PROJECT
Riverside Medical Office Build-Out
1450 Riverbend Parkway, Suite 200
Anytown, ST 00000
Job no. 26-118

DRAWING TITLE
BREAK ROOM 118
CASEWORK & QUARTZ COUNTERTOP
PLAN, ELEVATIONS & SCHEDULE

DRAWN: Axentra Drafting	CHECKED: D. Whitfield
DATE: 09/14/26	SCALE: AS NOTED
SHOP DWG NO.: SD-26118-118	FIELD VERIFIED: 10/05/26
SHEET	REVISION

DRAWING TITLE
BREAK ROOM 118
COUNTERTOP & CASEWORK
DETAILS & SLAB LAYOUT

1 SD-1 COUNTERTOP & CASEWORK PLAN – BREAK ROOM 118

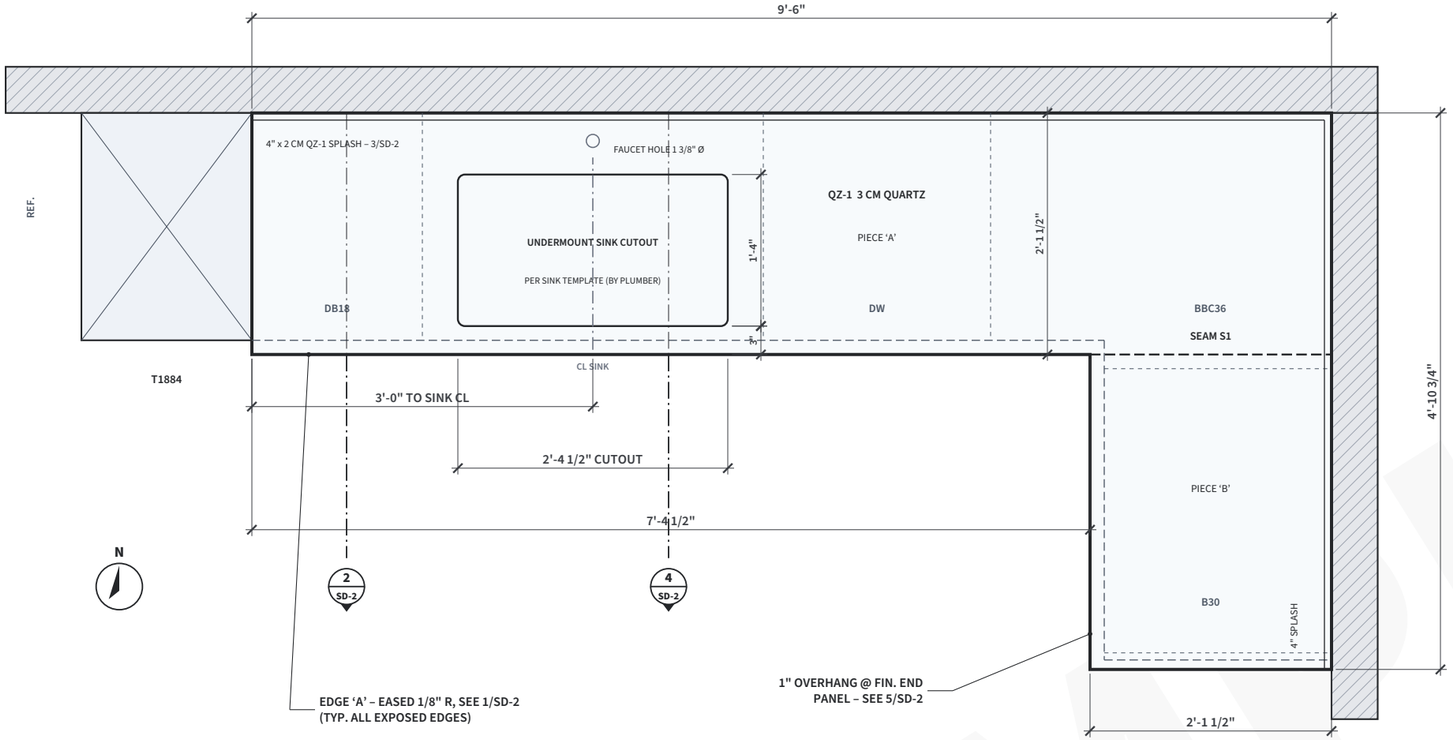
P. Nair, Lumen Architecture Studio – 10/02/26
Note: verify sink CL at rough-in (see Rev 1).

8. Rev 2: per architect review – confirm DW opening 24" clear; sink CL 3'-0" from tall cab.

4 SD-2 UNDERMOUNT SINK SECTION

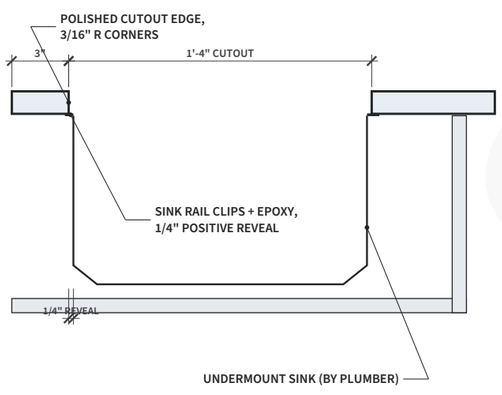
ARCHITECT / GC REVIEW STAMP
☐ Approved ☑ Approved as noted
☐ Revise & resubmit ☐ Rejected
P. Nair, Lumen Architecture Studio – 10/02/26
Note: verify sink CL at rough-in (see Rev 1).
